SUBJECT: Forwards response to NRC 980601 RAI re GL 96-06 w/regard to water hammer & two-phase flow assessments associated w/post-accident operation of drywell air coolers. C
A

Subject: *Request for Additional Information Regarding Generic Letter 96-06 Dated June 1, 1998 Concerning Nine Mile Point Units 1 and 2 (TAC Nos. M96836 & M96837)*

NMPI RESPONSE TO GL 96-06 RAI

NMP2 RESPONSE TO GL 96-06 RAI

NIAGARA MOHAWK
NINE MILE POINT NUCLEAR STATION UNIT NO. 1
REACTOR BLDG
CLOSED LOOP COOLING SYSTEM
SIMPLIFIED FLOW SKETCH

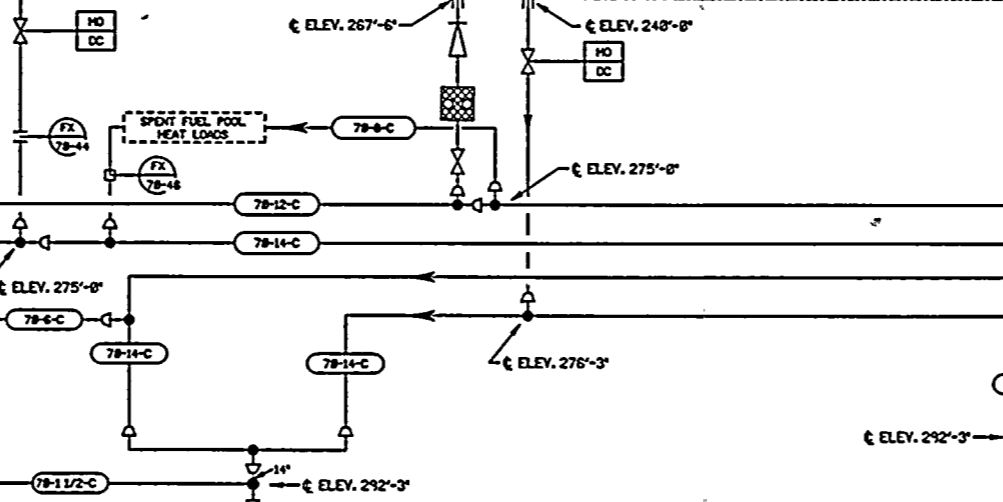
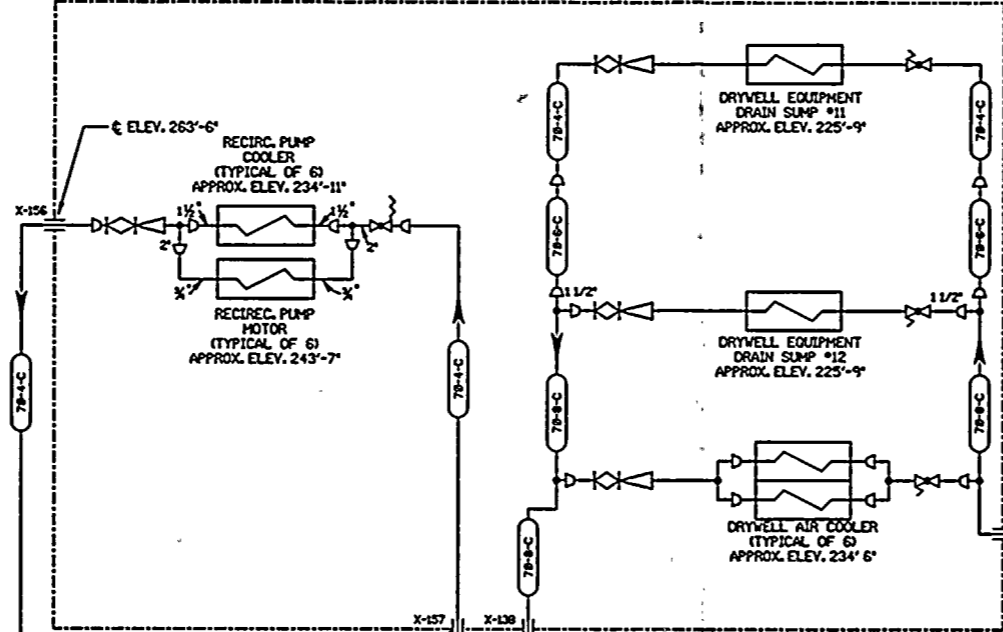
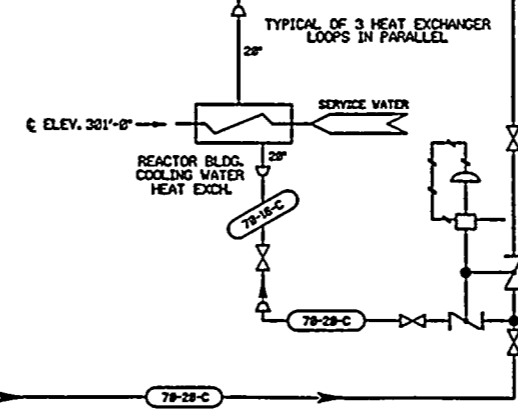
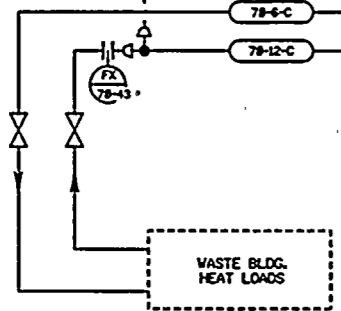
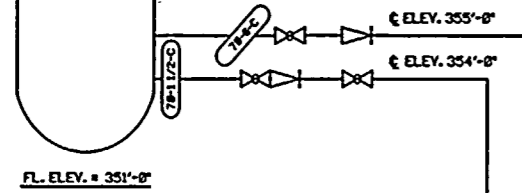
Provide a simplified diagram of the affected Cooling Water Systems showing major components, active components, relative elevations, lengths of piping runs, and the location of any orifices and flow restrictions.

The attached sketch provides all the requested information except lengths of piping runs. Complexity of RBCLC piping inside the drywell does not allow inclusion of piping lengths in the simplified sketch. Piping isometrics can be provided if more detail than shown on the simplified sketch is desired.

NIAGARA MOHAWK		NINE MILE POINT NUCLEAR STATION - UNIT 2 SCRBA, N.Y.	
SIMPLIFIED FLOW DIAGRAM REACTOR BUILDING CLOSED LOOP COOLING WATER SYSTEM			
SCALE	DRAWING NO 96-06 RAI SKETCH, SHEET 1

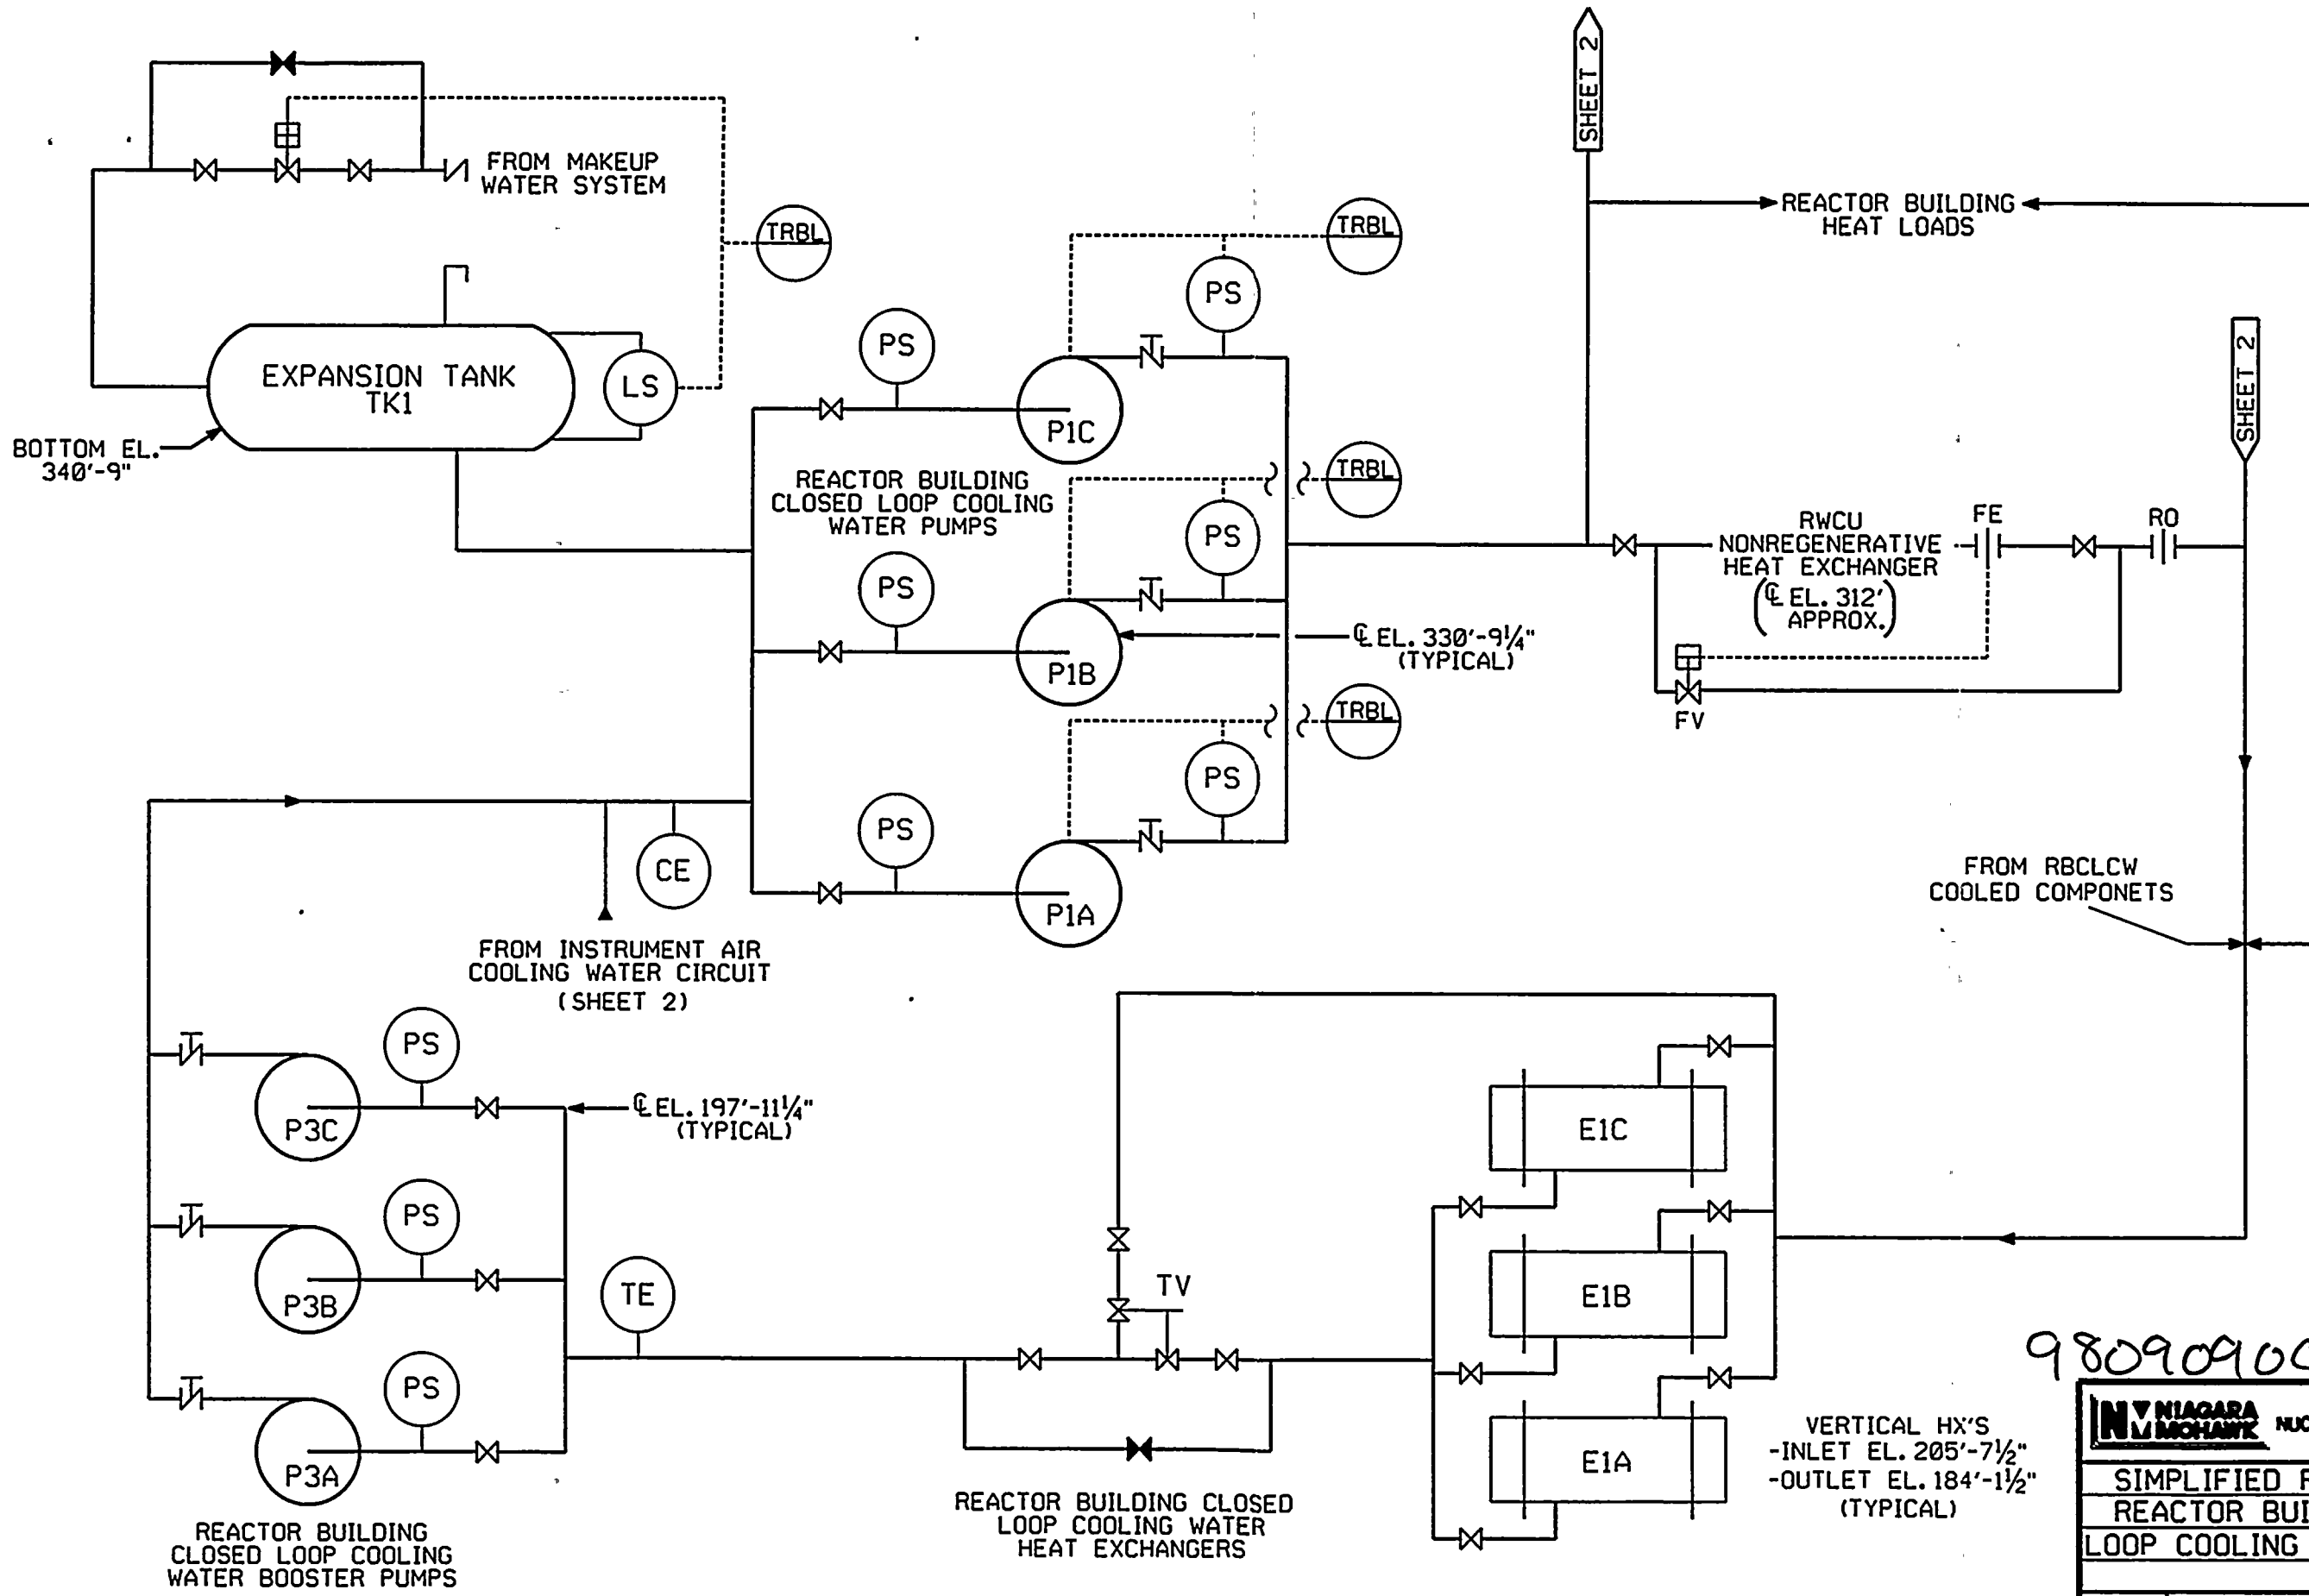
Provide a simplified diagram of the affected cooling water systems showing major components, active components, relative elevations, lengths of piping runs, and the location of any orifices and flow restrictions.

The attached sketch provides all the requested information except lengths of piping runs. Complexity of RBCLC piping inside the drywell does not allow inclusion of piping lengths in the simplified sketch. Piping isometrics can be provided if more detail than shown on the simplified sketch is desired.
